SUBJECT: Savannah River Site's Responses to the Regulatory Comments on the Treatability Study Data Report for Groundwater Injection and Discharge Canal Neutralization at the D-Area Groundwater Operable Unit (OU) (U) 2023 Data and Information (SRNS-TR-2024-00261, Revision 0, June 2024) SEMS Number: 63

**SRS Responses to South Carolina Department of Environmental Services Comments on the
Treatability Study Data Report for Groundwater Injection and Discharge Canal Neutralization at
the D-Area Groundwater Operable Unit (OU) (U) – 2023 Data and Information,
SEMS Number: 63 (SRNS-TR-2024-00261, Revision 0, June 2024)**

**SRS Responses to United States Environmental Protection Agency Comments on the
Treatability Study Data Report for Groundwater Injection and Discharge Canal Neutralization at
the D-Area Groundwater Operable Unit (OU) (U) – 2023 Data and Information,
SEMS Number: 63 (SRNS-TR-2024-00261, Revision 0, June 2024)**

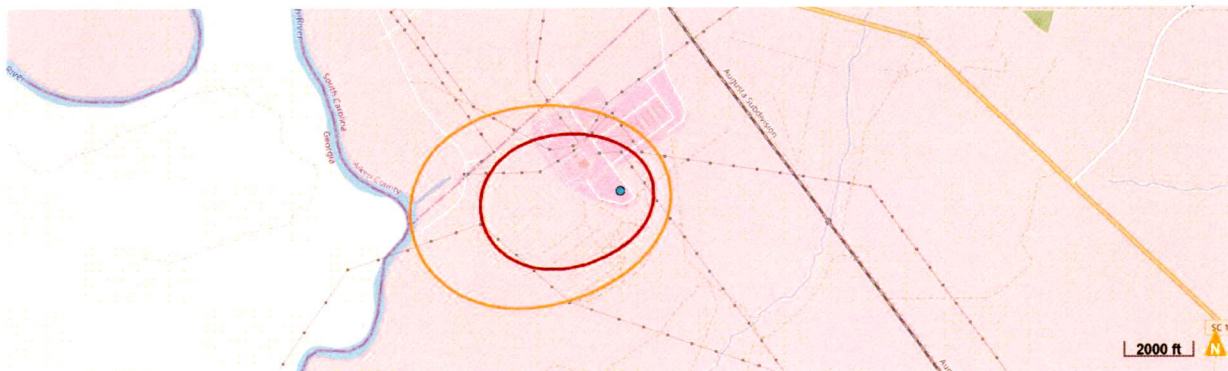
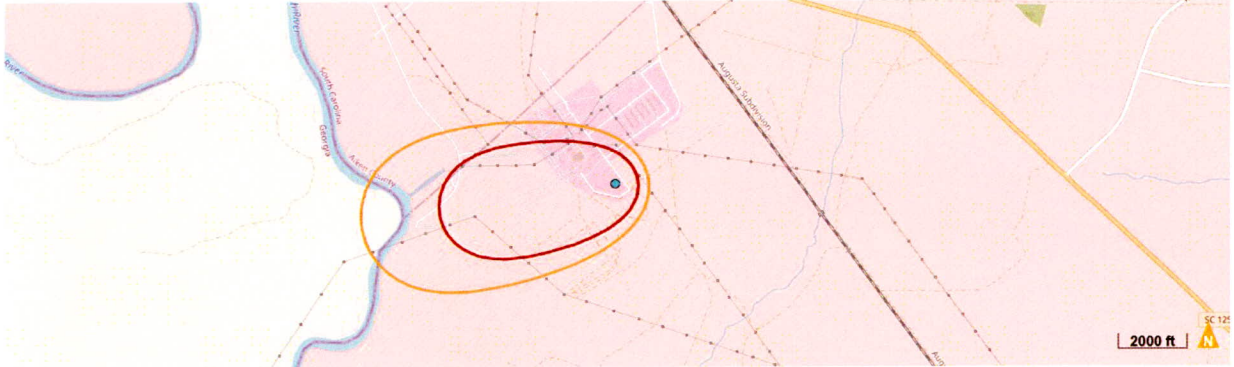
5. **Appendix D, DAG OU Treatability Study Injection Reevaluation, Section 2.0, Analytical Transport Modeling of Injected Water at the DAG OU, Pages D-6 and D-7 of D-12:** A number of assumptions were made for the transport modeling, but a sensitivity analysis was not conducted, so the extent to which the assumptions would impact the model results is unclear. For example, the aquifer hydraulic conductivity (K) was estimated as 20 feet per day (ft/day), even though slug testing indicated the maximum K is 15 ft/day. A sensitivity analysis should be conducted to evaluate the extent to which various parameters would impact the model; this should include, but not be limited to K, dispersion, and the injection flow rate. Please conduct a sensitivity analysis for the transport modeling and revise the TSDR to present the results.

Response: Agree/Clarification

Some parameter values used to estimate the impact on model results were changed to be more representative of the site conditions. The injection flow rate was assumed to be constant throughout time. However, changes in the aquifer hydraulic conductivity does impact the estimated extent of the injected water over time. Presented below are results from two scenarios where horizontal hydraulic conductivity (K_h) values were changed to 10 ft/d and 15 ft/d respectively. The red polygon shows the extent of the injectate without considering dispersion while the orange polygon shows the extent of the mixing zone (dispersion considered). Therefore, impact of dispersion are built into the model results as viewed.

$K_h = 10$ ft/d –

$K_h=15$ ft/d –

Changing the dispersion values will increase or decrease the extent of the orange polygon (no change in the red polygon) corresponding to increase or decrease dispersivity values. This is shown below by changing the dispersivity value to 500 ft and 50 ft respectively from a base value of 200 ft.

A full sensitivity analysis is beyond the scope of this Treatability Study Data Report. However, a quantitative groundwater model is being conducted for the D-Area Groundwater operable unit that will support the future remedial investigation report. No changes to the June 2024 Data Report are proposed.
